**Letter Support for Drained Basement
Proposed Affordable Housing Units
14-16 Marshall Avenue, 2-10 Berry Road & 5-9 Holdsworth Avenue Street, St
Leonard, NSW**

REQUEST FOR FURTHER INFORMATION

RE: Proposed Development DA56/2023

Groundwater Seepage Analysis
Proposed Affordable Housing Units
14-16 Marshall Avenue, 2-10 Berry Road & 5-9 Holdsworth Avenue Street, St Leonard, NSW

Seepage Analysis Result

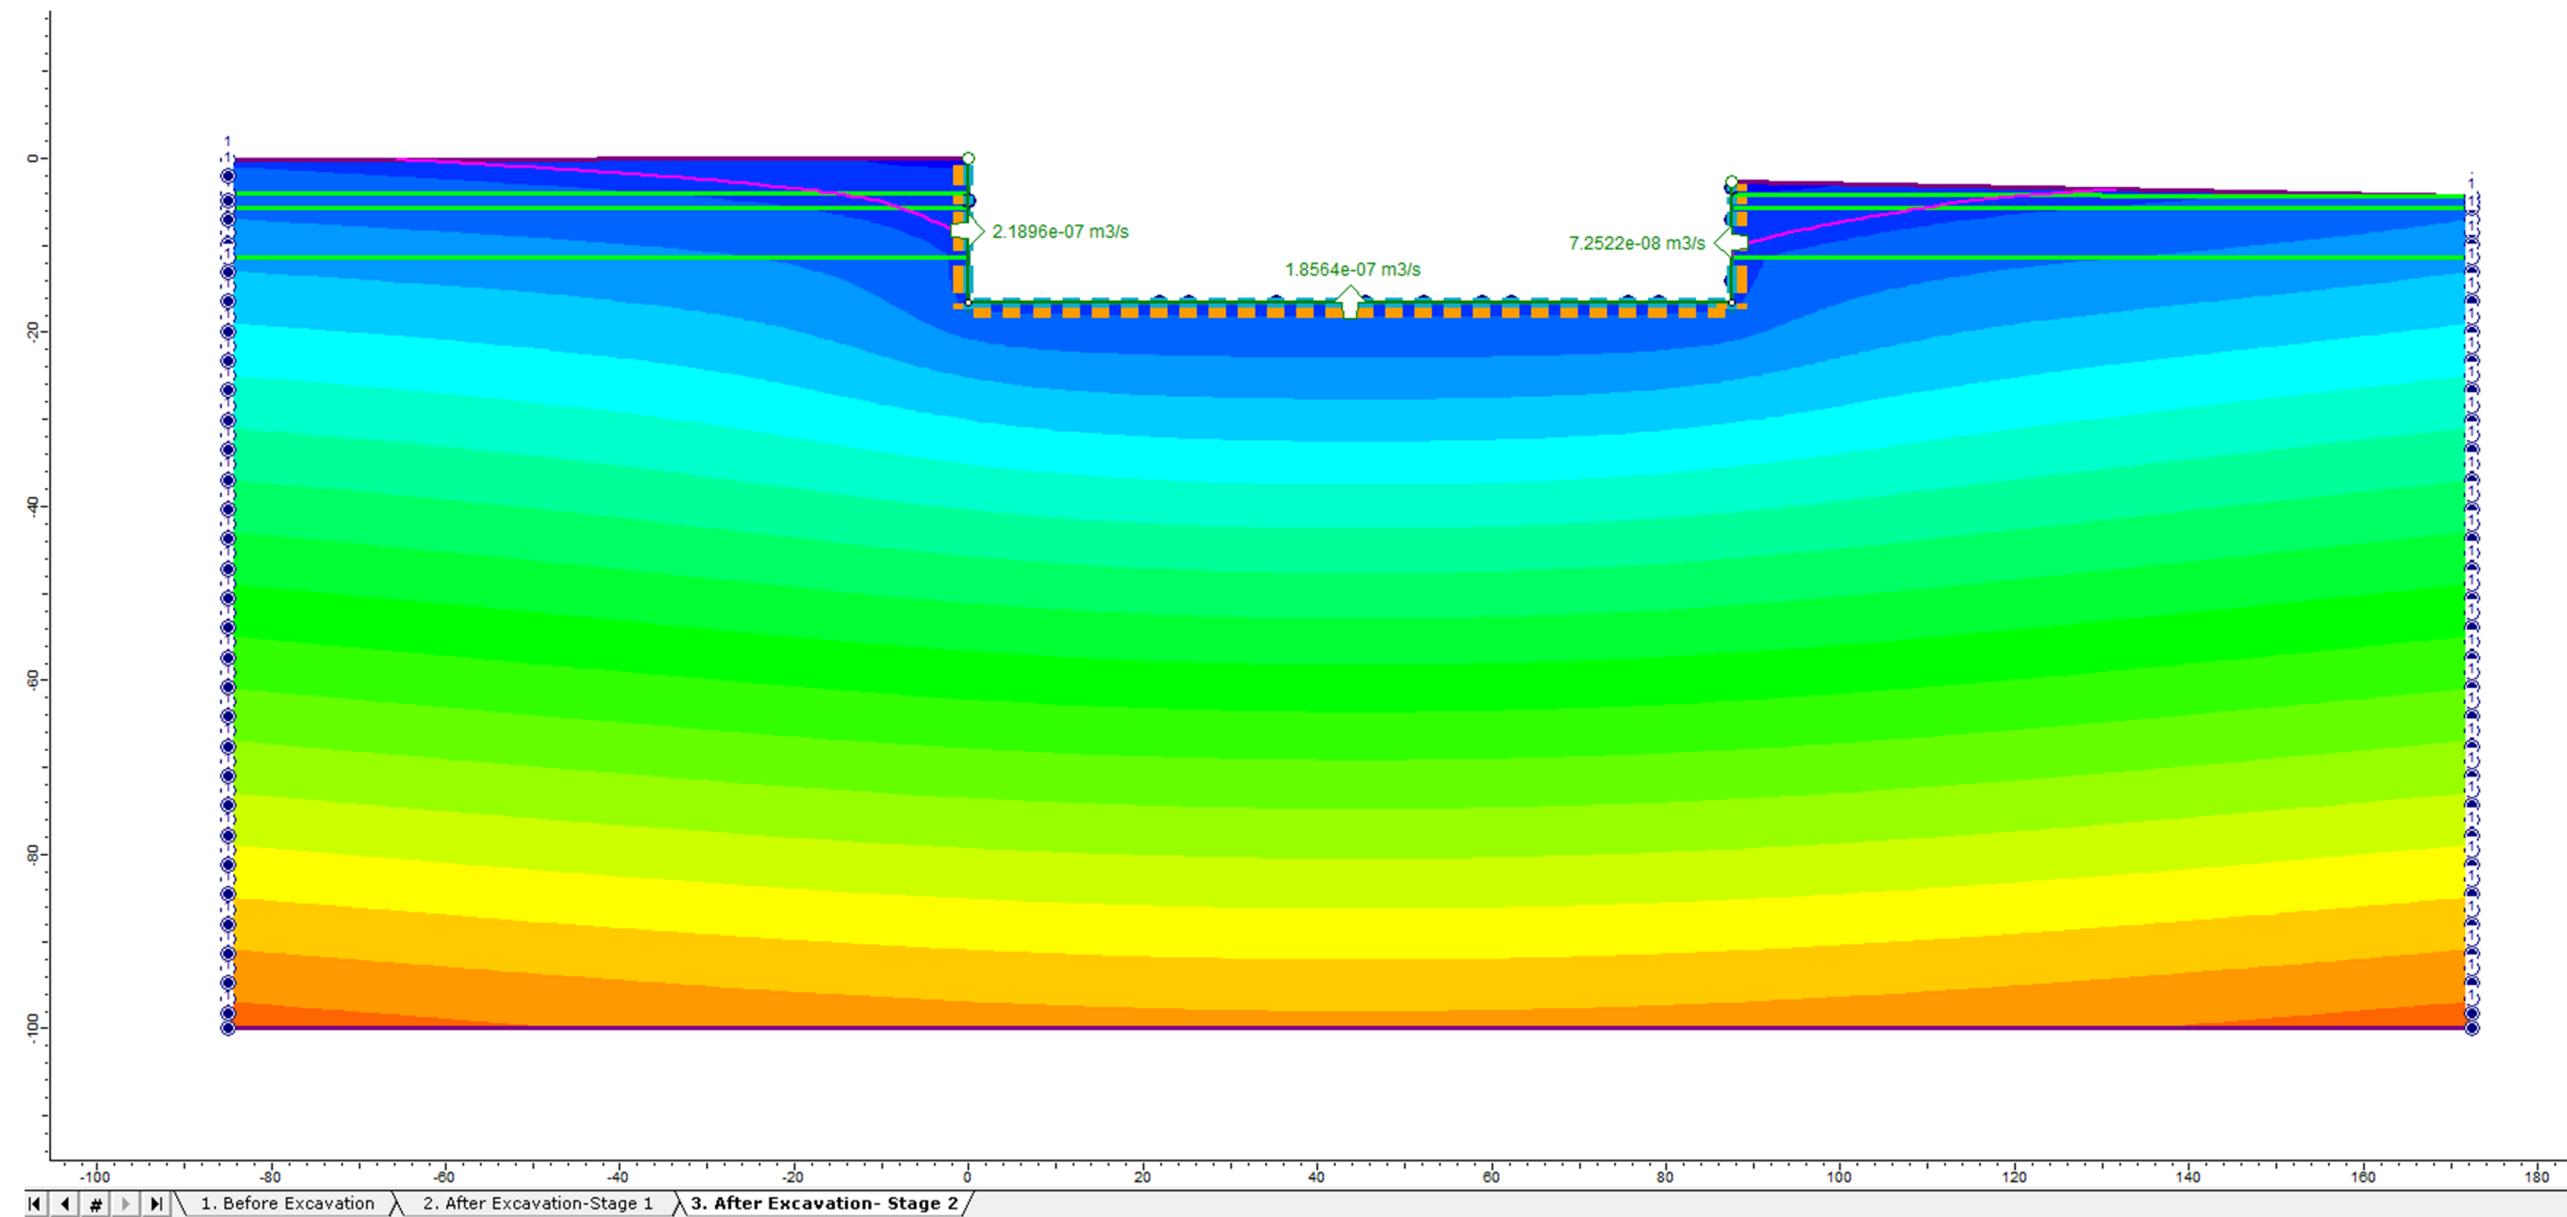
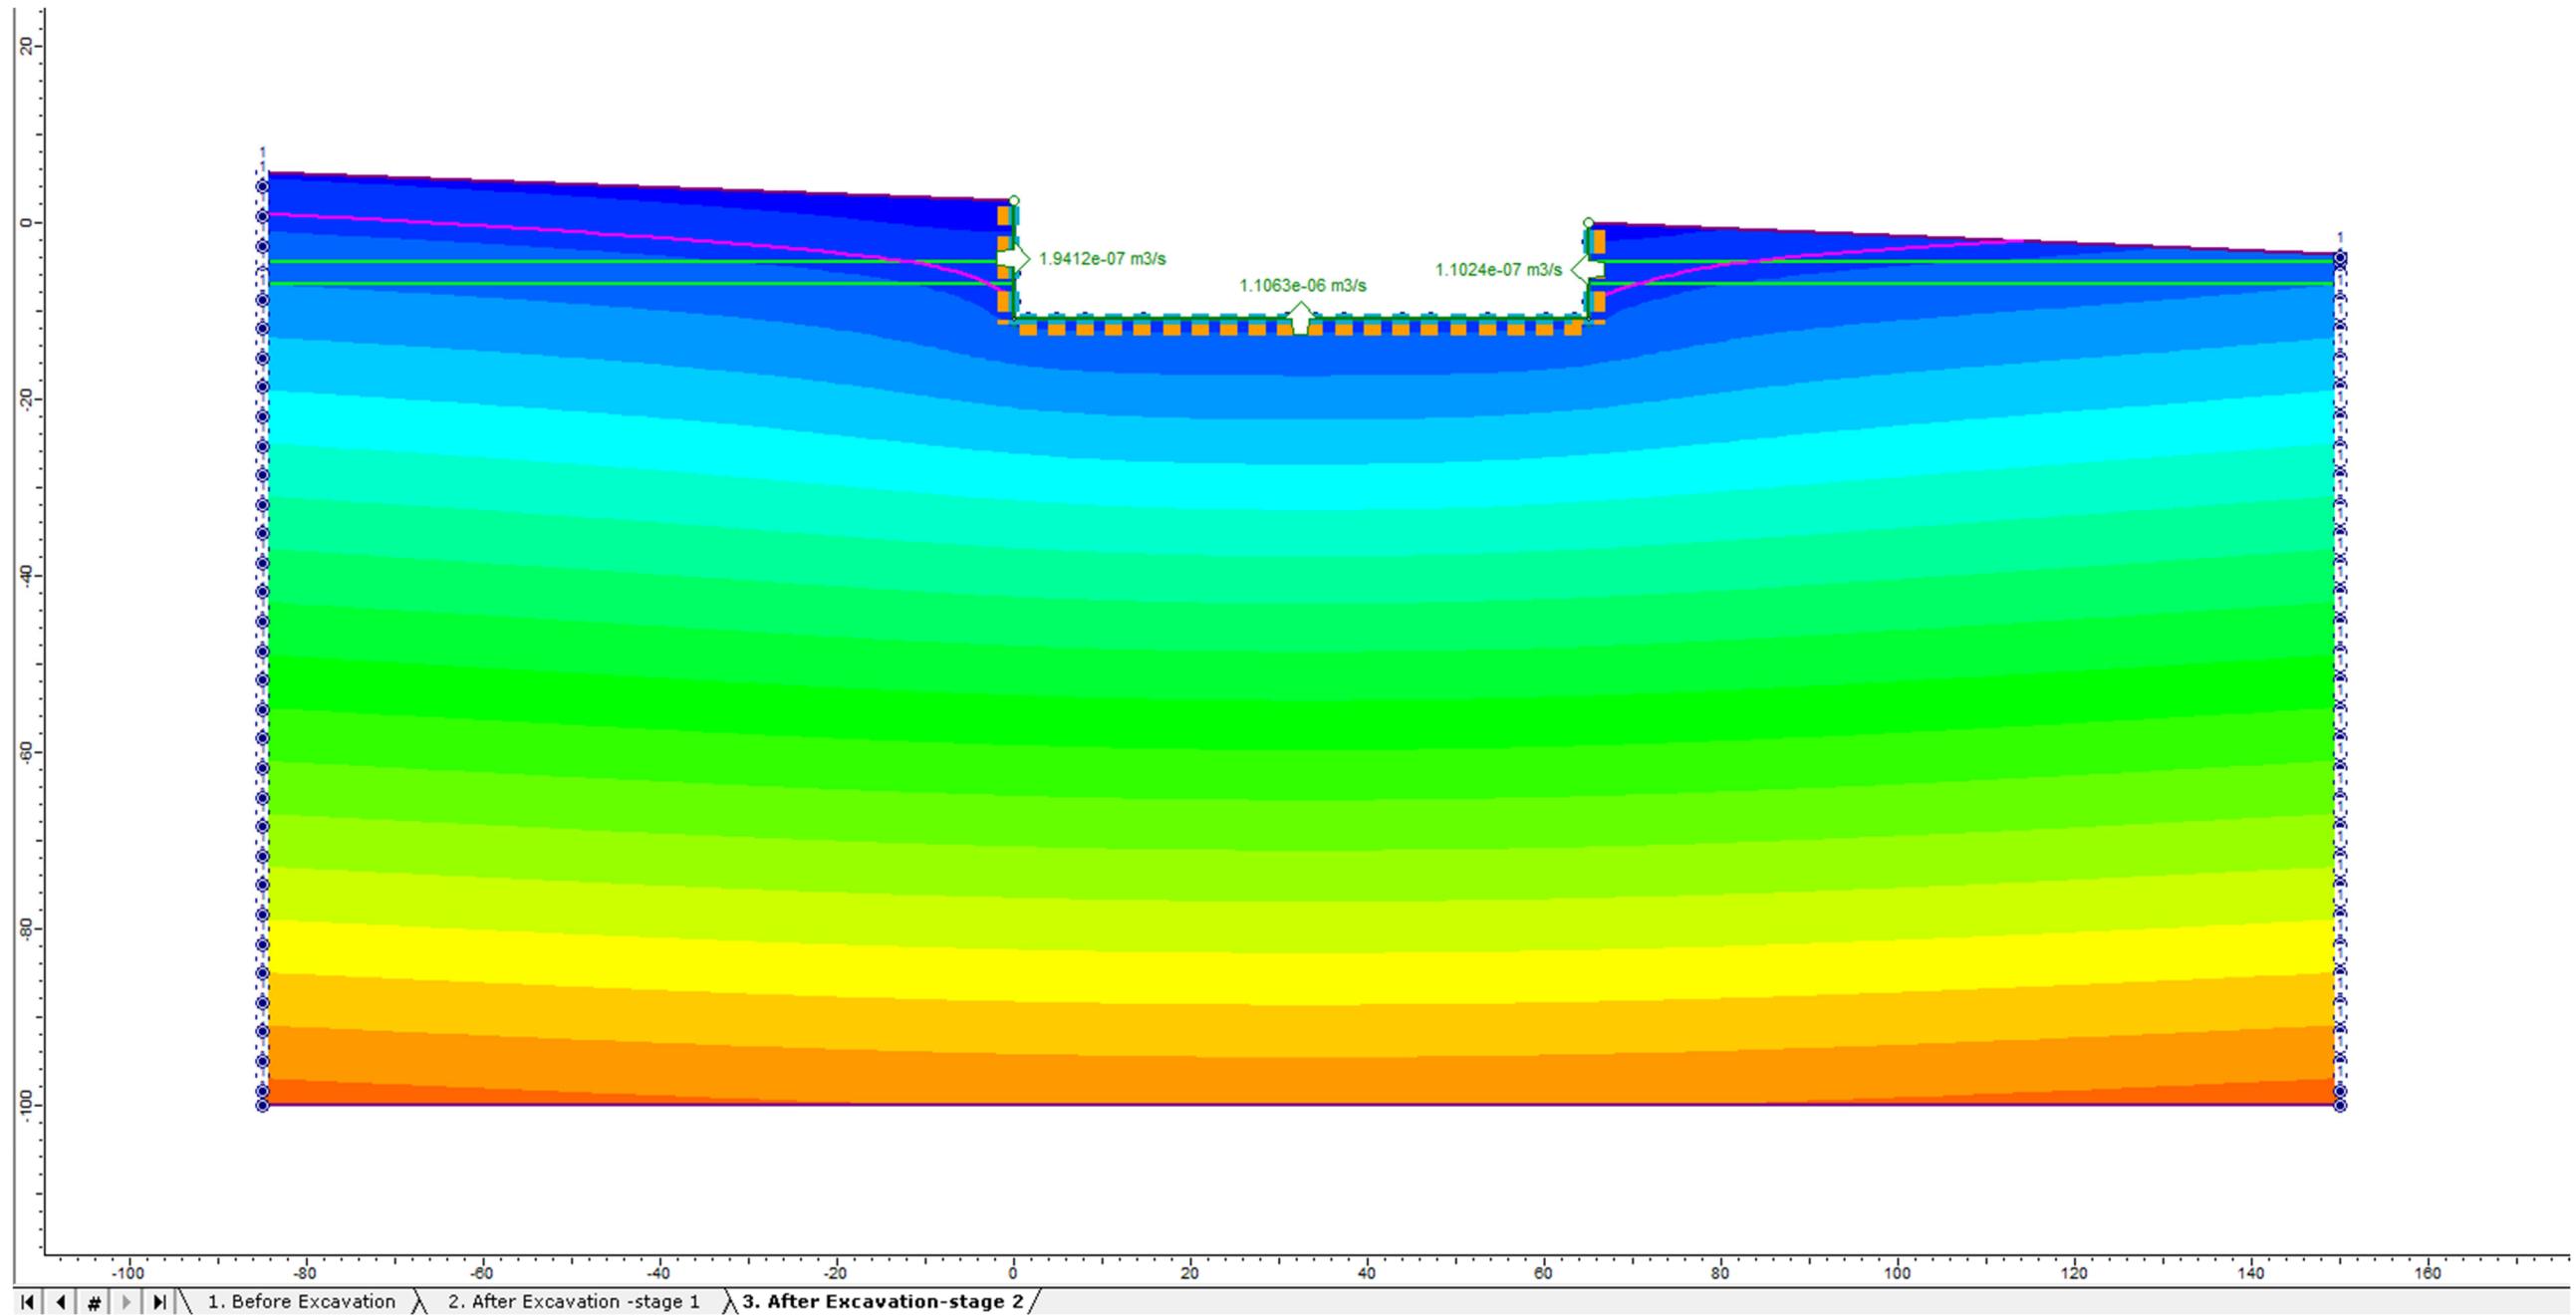
1. Considering a drained basement design is proposed, WaterNSW and the NSW Department of Climate Change, Energy, the Environment and Water (DCCEEW) will require additional modelled data to support a hydrogeological review and assessment. The Geotechnical report/Dewatering Management Plan (or equivalent) will need to be updated accordingly and satisfy requirements detailed in the Minimum requirements for building site groundwater investigations and reporting. Further information can also be found at
<https://www.industry.nsw.gov.au/water/science/groundwater/aquifer-interference-activities>.

The data provided must include but not limited to the following: 3 months' worth of groundwater monitoring; details of 3 monitoring bores; volume and duration of water take; suitability of the volume estimation method; drawdown monitoring and details of hydraulic conductivity.

Using the geotechnical models and the permeability values shown in Table 2 above, seepage analysis was carried out using Rocscience Software RS2, a two-dimensional finite element computer program. For the sections analysed, the expected inflow has been assessed for the section per metre length of the basement based on the permeabilities given above.

The result of the analysis indicates an inflow rate in the order of 1.44ML/180 days during construction phase and 2.9ML/year during operational phase. The results of the analysis are presented as graphical output in Figures 3 & 4.
